TO: Mayor Andre Dickens, City of Atlanta  
ATTN TO: Monique Forte, Planner III, City of Atlanta  
RE: Development of Regional Impact Review  
FROM: Mike Alexander, Director, ARC Center for Livable Communities

**Name of Proposal:** 1400 Murphy DRI 3716

**Description:** A DRI review of a proposal to build 614,036 SF of industrial warehouse space in two buildings on an approximately 31.5-acre site adjacent to the Oakland City MARTA rail station. The site was previously a biscuit factory and is bounded on the south by single-family homes and the east by Sylvan Middle School. There is a MARTA rail station entrance at the northwest corner of the site.

**DRI SITE PLAN**

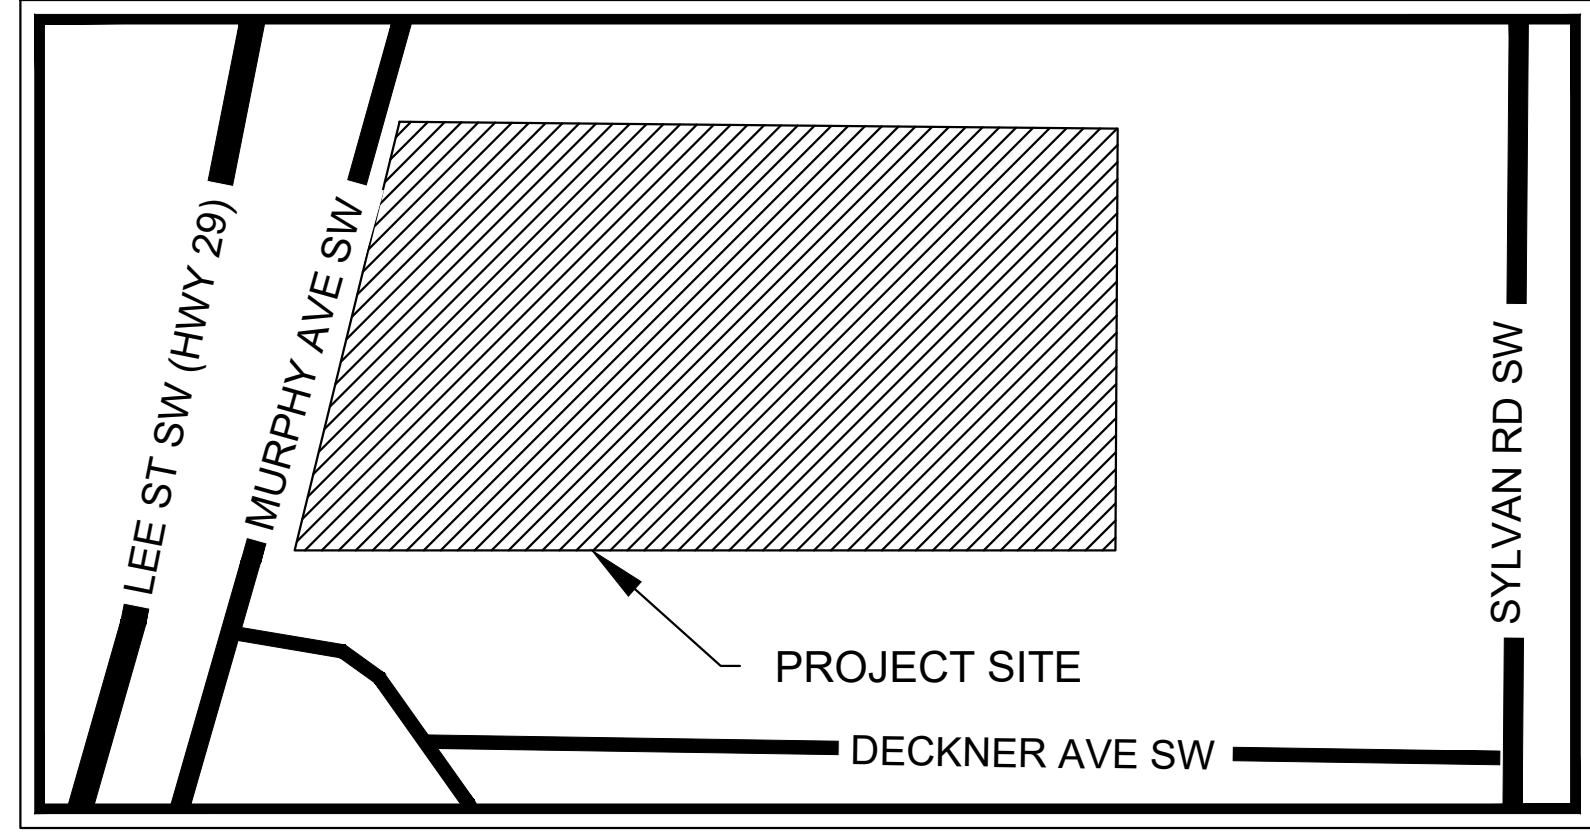
*In addition to not adding new uses which support transit, the project will add a substantial amount of new heavy vehicle traffic on Murphy and Dill Avenues – immediately adjacent to the dedicated MARTA station entrance and a future BRT station entrance – which directly conflicts with the need to make these station areas more pedestrian friendly.*

*All of the trucks accessing the project – 340 daily – will utilize Dill Avenue to reach Murphy Avenue and the site. The roadway width is extremely limited at this complex intersection, and trucks will have to either enter opposing traffic lanes or drive over a sidewalk to make the extremely tight right (southbound) turns, which will create dangerous and disruptive pedestrian and traffic impacts. This is even more challenging as this truck movement will occur directly at the street frontage of Gateway Capitol View, a senior living community.*

The Lee Street/Dill Avenue/Murphy Avenue existing intersection is very complex and must accommodate a range of modes. This intersection will become more complex when the BRT terminus station is completed. At the same time, the ROW is very constrained and there is limited opportunity to adjust it. Most of the truck traffic generated by the project traveling through this intersection will need to enter opposing lanes in order to make the turns which will create extensive traffic congestion which will conflict with future BRT movements and with the existing bus route along Murphy Avenue.

Some of the trucks can physically only make required turns by running over existing sidewalk as noted in the TIS: " It should be noted that the sidewalk located adjacent to the westbound right-turn at the intersection of Lee Street (US 29/SR 14/SR 139/SR 154) at Campbellton Road/Dill Avenue is currently within the wheel path of a typical WB-67 Truck. Therefore, an expansion or redesign of the existing pedestrian sidewalk facility should be considered and monitored, based on actual truck traffic." Projects in the immediate vicinity of transit stations should be removing pedestrian hazards rather than creating additional ones.
